## HCCP NEG SPEC BUILDING JSP17-30

Public hearing at the request of HCP Land, LLC for Preliminary Site Plan, Woodland Permit, and Stormwater Management Plan approval. The subject parcel is located in section 1 in the Haggerty Corridor Corporate Park, west of Cabot Drive, north of Thirteen Mile Road, and west of Haggerty Road. It is approximately 14.06 acres and zoned OST (Office Service Technology). The applicant is proposing to build a 210,000 square foot, 4-story office building along with associated site improvements, including parking and utilities. The plan also includes an extension of Cabot Drive north to the parcel.

**Planning Review**  
**HCCP NEG Spec Building**  
 JSP 17-30

**Review Date:** April 20, 2017  
**Review Type:** Preliminary Site Plan  
**Project Name:** HCCP NEG Spec Building JSP 17-30  
**Plan Date:** 4-10-2017  
**Prepared by:** Kirsten Mellem, Planner  
**E-mail:** kmellem@cityofnovi.org **Phone:** 248.347.0484

DRAWING NUMBER:  
**L-1.2**

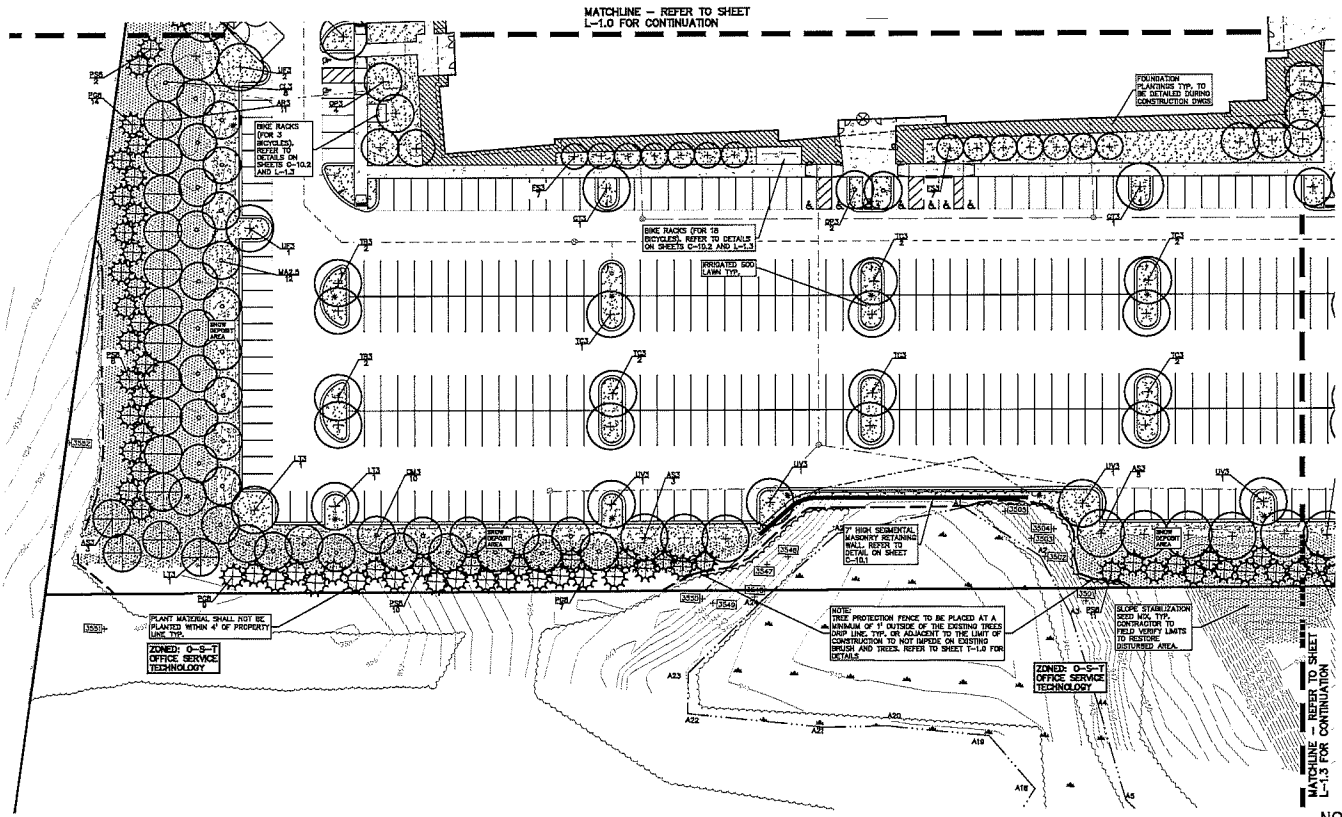
The plans for the Spec. Office Building (i.e., *Dimension and Paving Plan*, Sheet C-4.3) indicate that the construction of the southernmost parking lot includes impact to the northern section of the 25-foot wetland buffer area of Wetland A. This area of construction does not include direct impacts to Wetland A.

ISSUED FOR:  
DATE: 10-17-17  
SITE PLAN APPROVAL  
FINAL SITE PLAN APPROVAL  
DRAWING DATE: 5-4-17  
PROJECT NUMBER: 16062  
SHEET NUMBER: PE-1

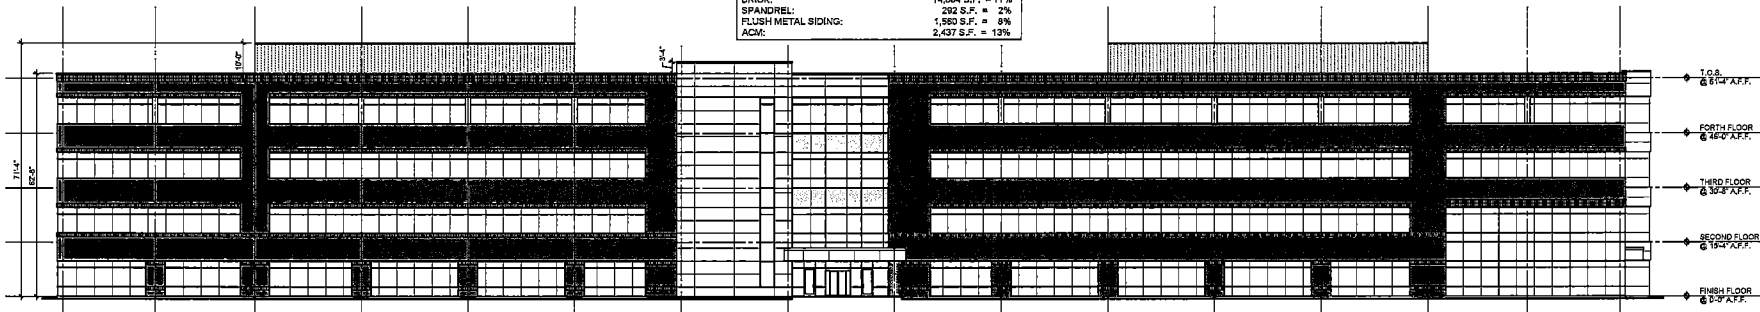
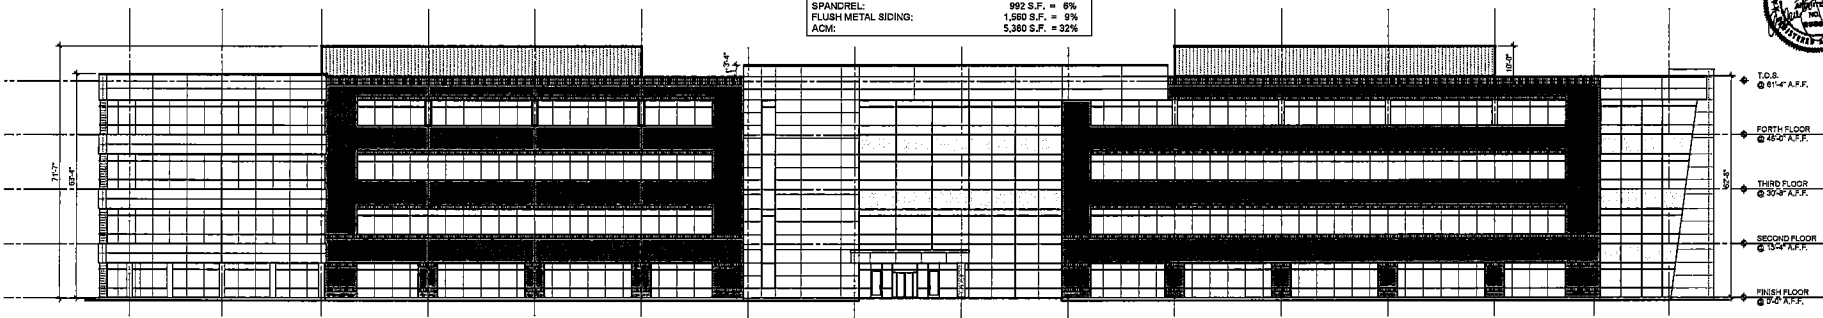
No comments to address.

Figure 1. City of Novi Regulated Wetland & Woodland GIS Coverage Map (approximate project boundary shown in red). Regulated Woodland areas are shown in green and regulated Wetland areas are shown in blue.

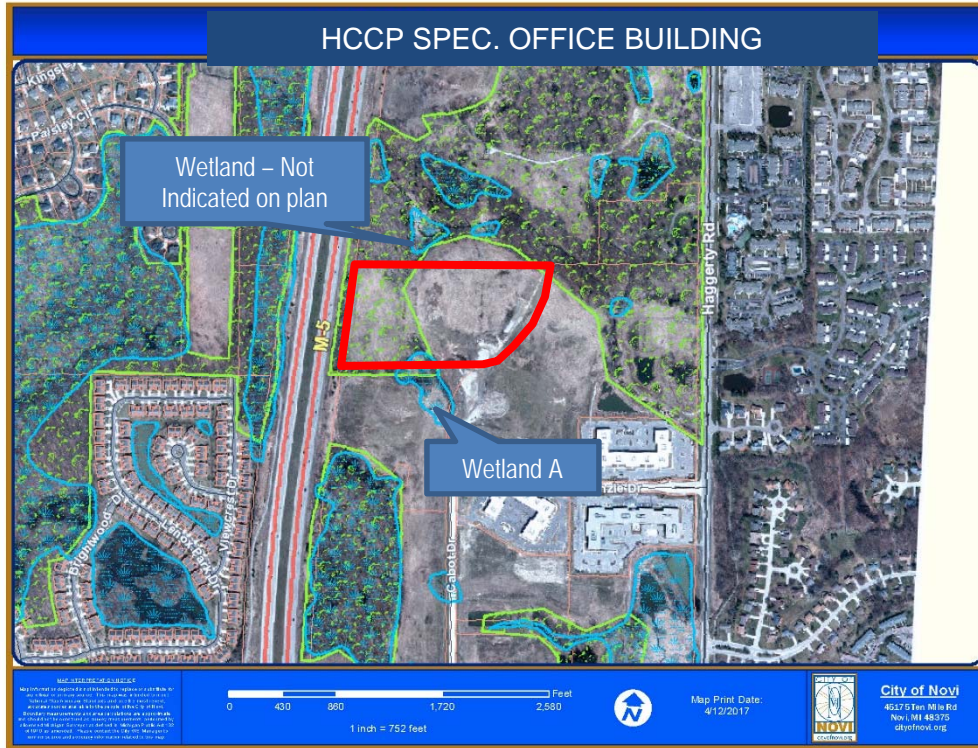
Based on our review of the Plan, Novi aerial photos, Novi GIS, the City of Novi Official Wetlands and Woodlands Maps (see Figure 1, attached) it appears as if this proposed project site contains City-regulated wetland.

ECT has reviewed the City of Novi Official Wetland and Woodlands Map and completed an onsite wetland verification on April 27, 2017. As noted above, the site does contain area mapped as City regulated wetland/watercourse (Figure 1). One (1) wetland area (i.e., Wetland A) has been indicated on the plans. It is our understanding that this wetland was previously (2015) delineated by King & MacGregor Environmental, Inc. (KME).
